Subject: Livestock Water Tank Application - Yoast Pond 011A

Our office is in receipt of an application for a Livestock Water Tank (LWT) for the subject dam.

Application for Livestock Water Tank and Erosion Control Dam

DRAWING TITLE: **POND 011A ASBUILT**

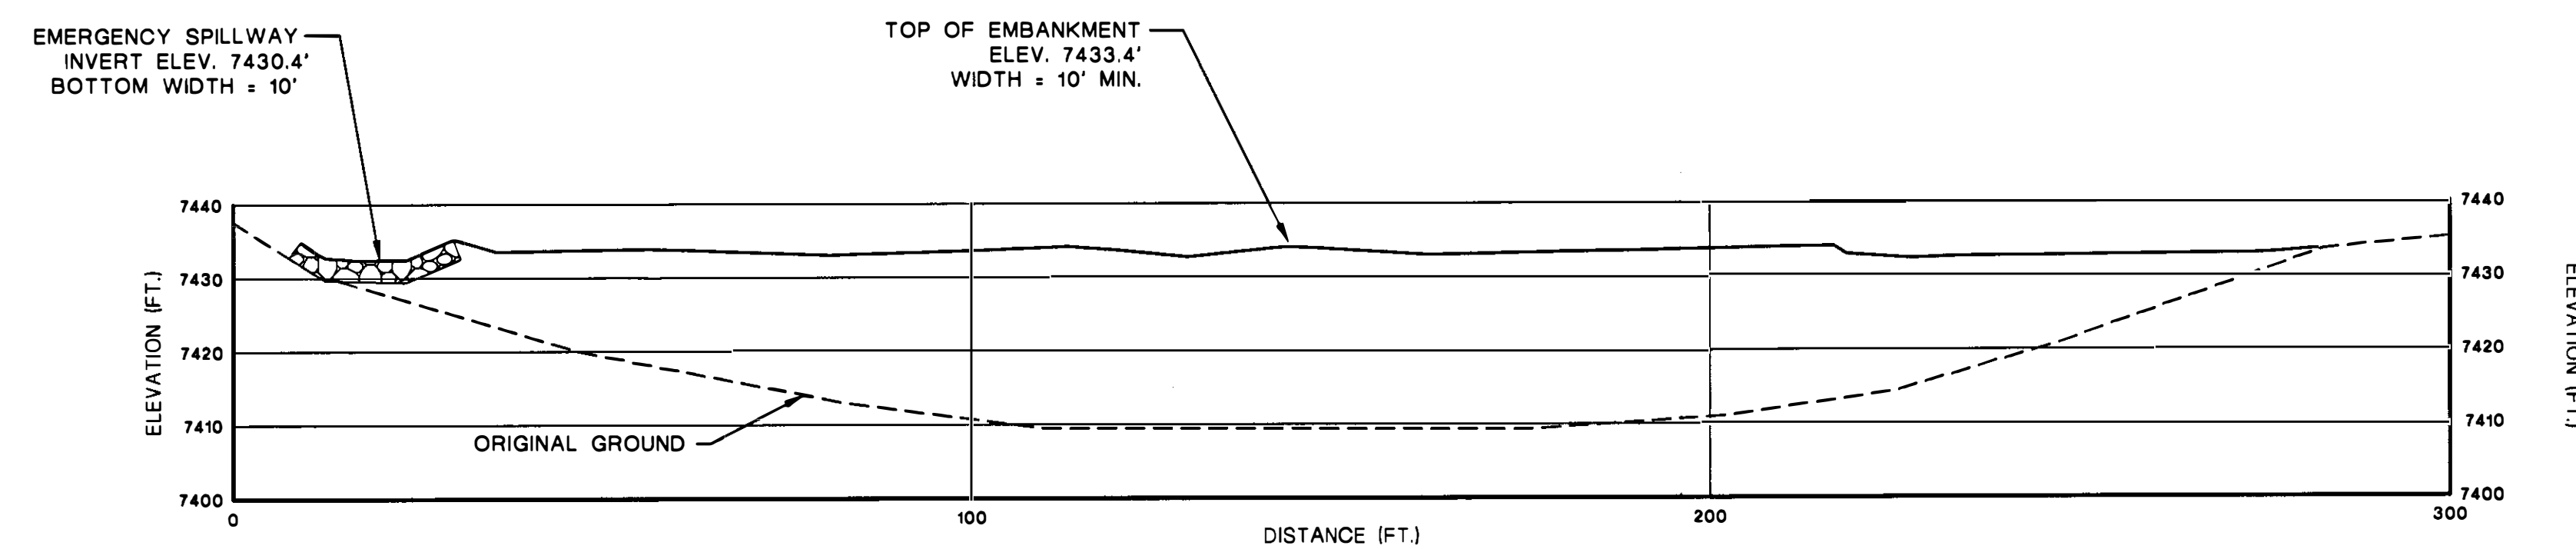
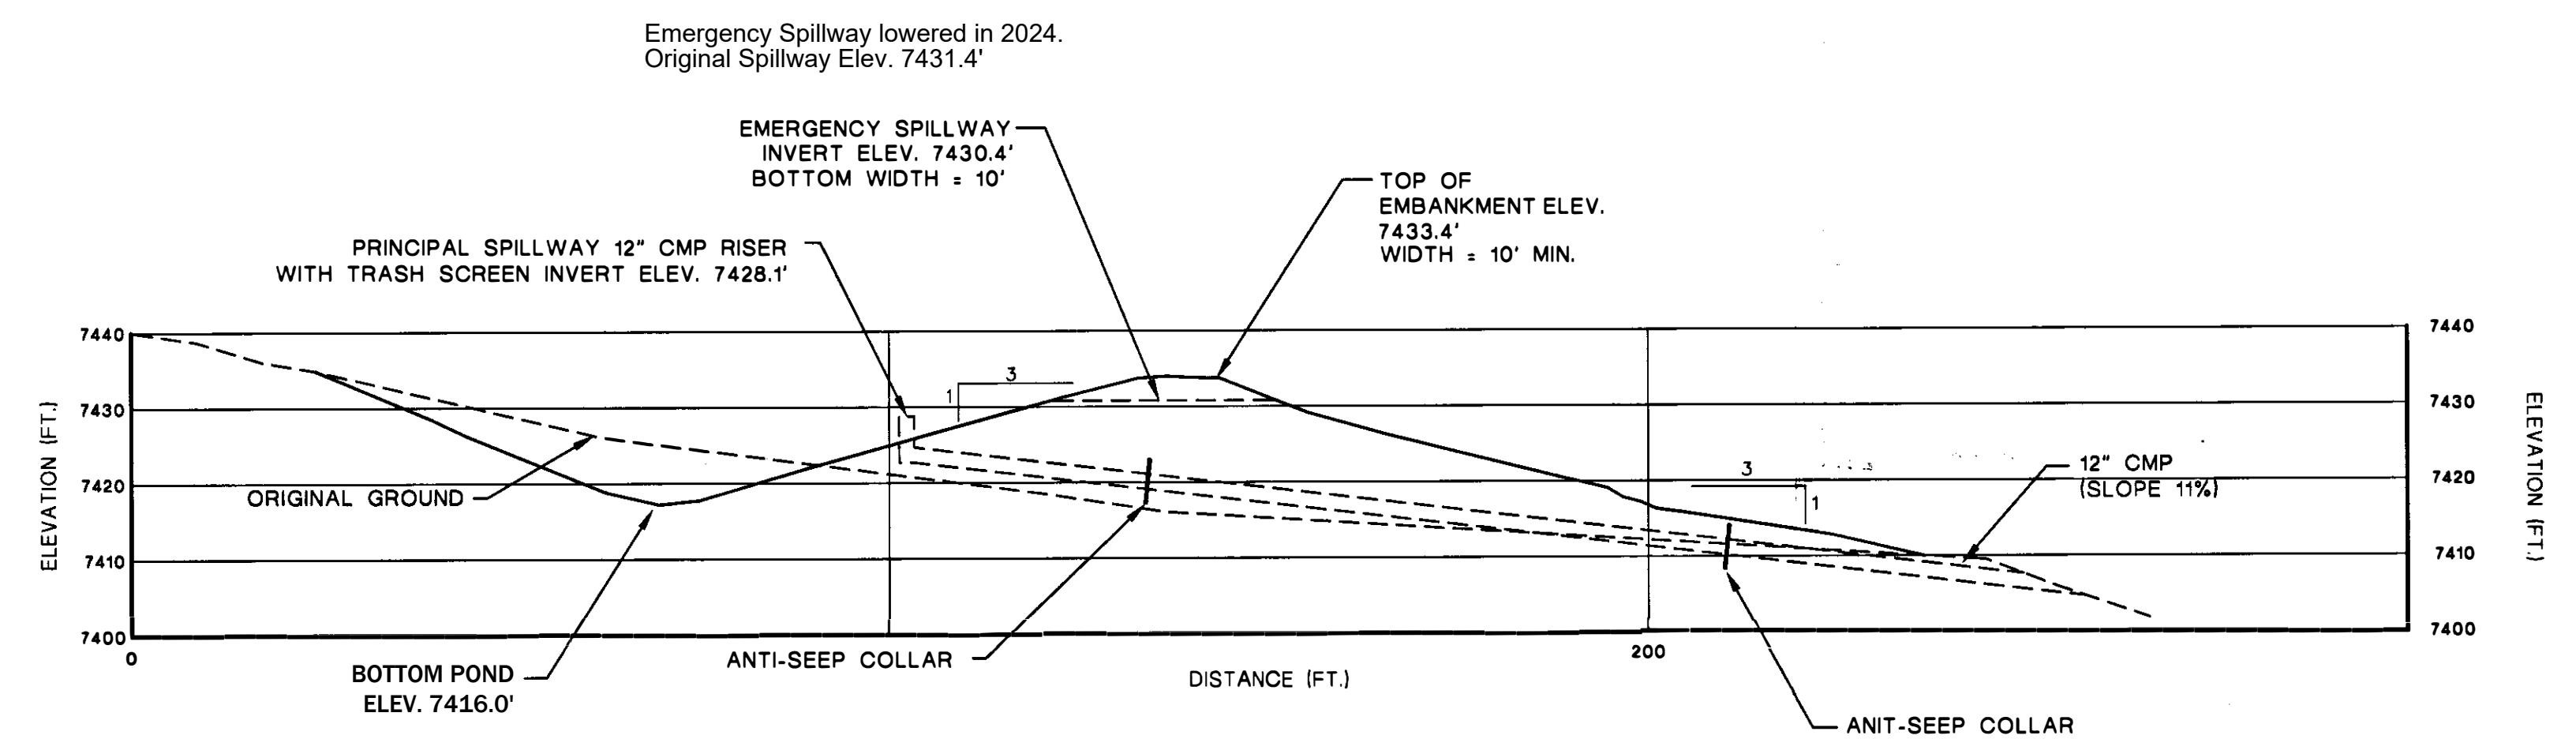
Based on the review of the subject application, the status of the dam's low level outlet:
The dam has not been constructed with a low-level outlet

Status of the spillway: Existing

Spillway size in feet: 10

The recommended spillway size in feet based in the drainage area is: 8

Spillway size in relation to the drainage area upstream of the dam:
is/will be proper for that recommended for the drainage area upstream of the dam

The application has been: Approved
